## Report on a Publicly Notified Resource Consent Application

<b>Application Reference:</b>	<b>RMA/2020/673</b>
<b>Applicant:</b>	Ryman Healthcare Limited
<b>Site address:</b>	100-104 Park Terrace, 20 Dorset Street
<b>Legal Descriptions:</b>	Lot 2 DP 13073, Lot 1 DP46369, Lot 1 DP 46569, Pt Town Res 23 Town of Christchurch and Pt Town Res 25 City of Christchurch
<b>Proposal:</b>	Construction, operation and maintenance of a comprehensive care retirement village
<b>Zoning:</b>	Residential Central City
<b>Overlays and map notations:</b>	Central City Building Height: 14m Overlay Central City Building Setbacks (Park Terrace) Category 3: Lower Noise Area Central City Outer zone Liquefaction Management Area Flood Management Area Heritage Item: 1305 Former Bishops Chapel and setting, Heritage Setting: 470 Park Terrace and Salisbury Street – Central City Local Distributor Roads
<b>Activity status:</b>	Restricted Discretionary
<b>Application Reference:</b>	<b>RMA/2020/679</b>

<b>Applicant:</b>	Ryman Healthcare Limited
<b>Site address:</b>	74 Park Terrace
<b>Legal Descriptions:</b>	Lot 1 DP 77997
<b>Proposal:</b>	Construction, operation and maintenance of a comprehensive care retirement vil

Figure 3: North façade B02  
Source: Application documents

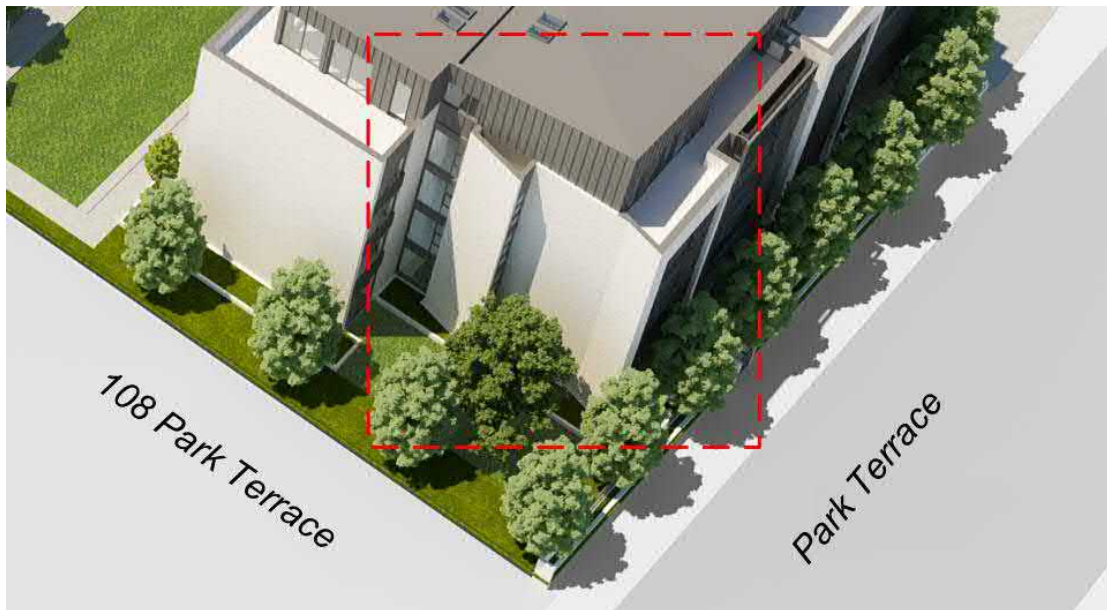
91. North façade of B02 (illustrated below). Ms Schroder considers that this elevation while angled, is tall and relatively blank, with additional roof height, with potential for a high level of reflectance. It does not contain many of the smaller detailed elements, such as glazing and balconies, found on most of the other building façades on the site. Ms Schroder considers that it results in an aspect that is out of context with the remainder of development within this urban block and will be visually dominant and will have a moderate to high visual impact on the user experience and scale, primarily pedestrians and cyclists, of Park Terrace, but more generally users of the street when approaching from the north.

While the boundary treatment and tree planting will potentially provide some filtering of this façade, this may be limited given the constraints on the site from the basement car parking. I agree with Ms Schroder on this and consider that due to its relative blankness, scale and location, the visual effects of this elevation from the street scene will be at least minor. However, I consider this acceptable given the overall visual quality of the development.

Figure 6: Recession plane breaches NW (Bishopspark)

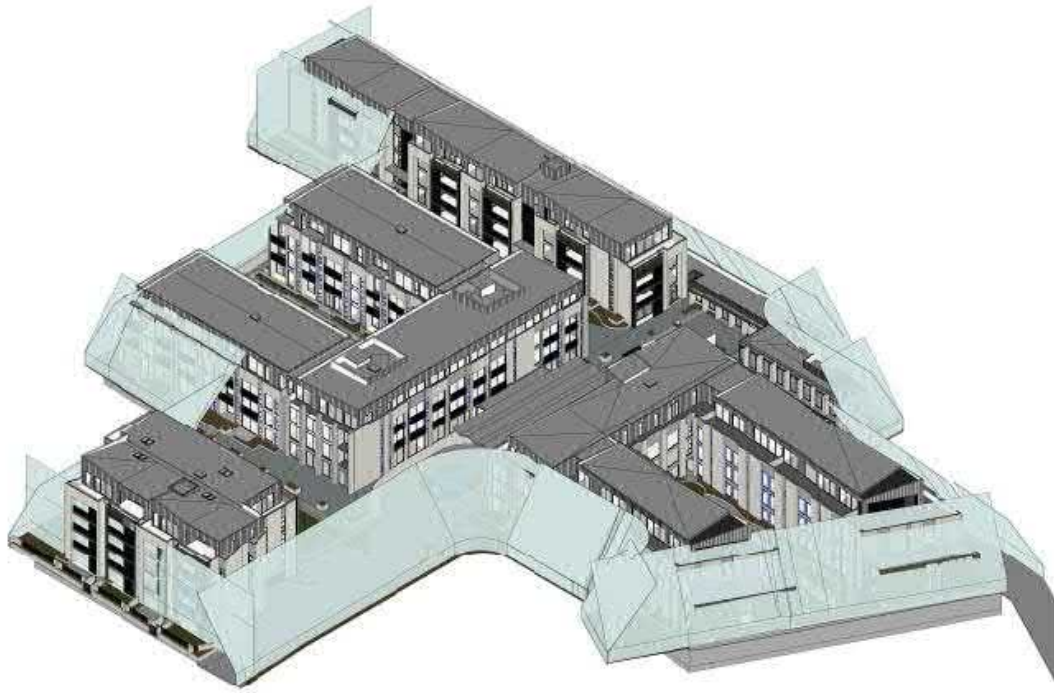
96. The proposed buildings also breach recession planes at almost all boundaries, albeit at various heights, lengths and depths. Similar to the height intrusions, the applicant has provided a number of useful drawings which clearly shows the areas of buildings which intrude the recession planes, see below. The relevant assessment matters at 14.15.28 require consideration of a. any effect on the amenity of neighbouring properties, including through loss of privacy, outlook, overshadowing or visual dominance of buildings and b. the extent to which the intrusion is necessary to enable more efficient, cost effective and/or practical use of the remainder of the site, or the long term protection of significant trees or natural features on the site.

Figure 4: South façade B02 (Bishopspark)

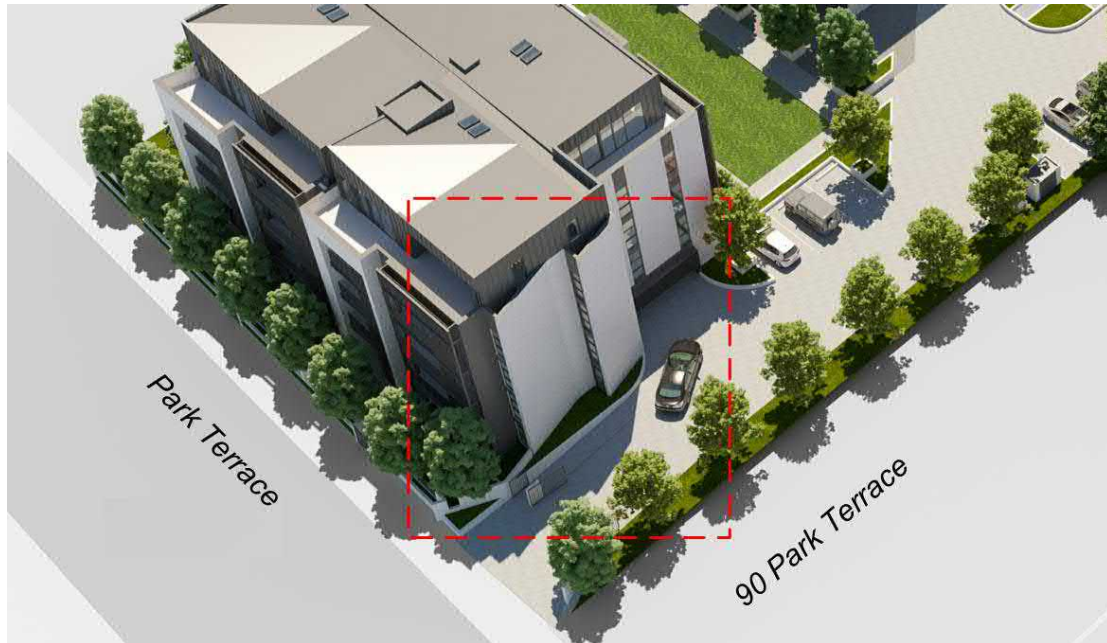
116. With regard to 90 Park Terrace, the southern façade of building B02 (*illustrated below*) while angled, is tall and relatively blank, with additional roof height increasing the visual bulk, with potential for a high level of reflectance. Ms Schroder considers that will result in a moderate to significant visual impact, resulting in visual dominance, in respect to 90 Park Terrace and to a degree, albeit at greater distance on 84 Park Terrace. However I note that written approval has been provided by the owners and occupier of 90 Park Terrace and therefore any effects on this person are to be disregarded.

Figure 10: Building B07

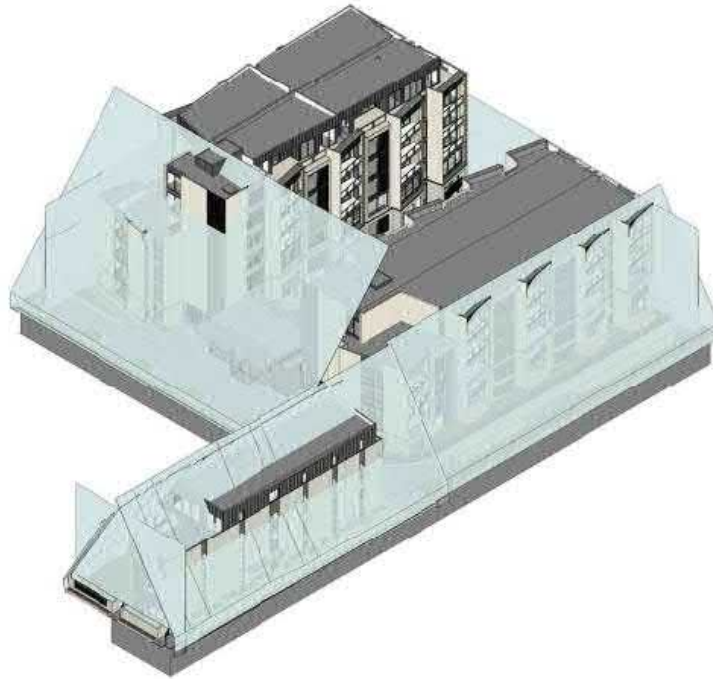
166. In regard to B08, while below the 20m height limit, there is a recession plane intrusion of some 40m in length and up to 6m in height (*illustrated below*). This is a substantial breach, in relatively close proximity to the boundary with the apartment building at 15 Peterborough Street, on the property's western aspect, with the units' balconies and large areas of glazing on this aspect. Ms Schroder considers that the additional building bulk projecting into the recession plane for the extended length will have an adverse impact upon the visual amenity and outlook of western neighbours located on the 2<sup>nd</sup> and 3<sup>rd</sup> floors of the adjacent apartment block and I concur with her on this. Ms Skidmore accepts that the development will create shading of this property in late afternoon and this will occur on indoor and balcony living spaces of some those units that face west towards the development. In terms of privacy, building B07 will have narrow windows facing east with a primary orientation towards the west, thus any overlooking effects to the neighbouring property are considered to be limited. I consider that the proposed development will have an impact on the visual amenity and outlook of the residential units in the adjacent apartment buildings and consider that these effects will be at least minor. However, I consider it to be acceptable given the Residential Central City zoning of the site and the Plan's allowance for a greater scale of buildings and density of development in this location.
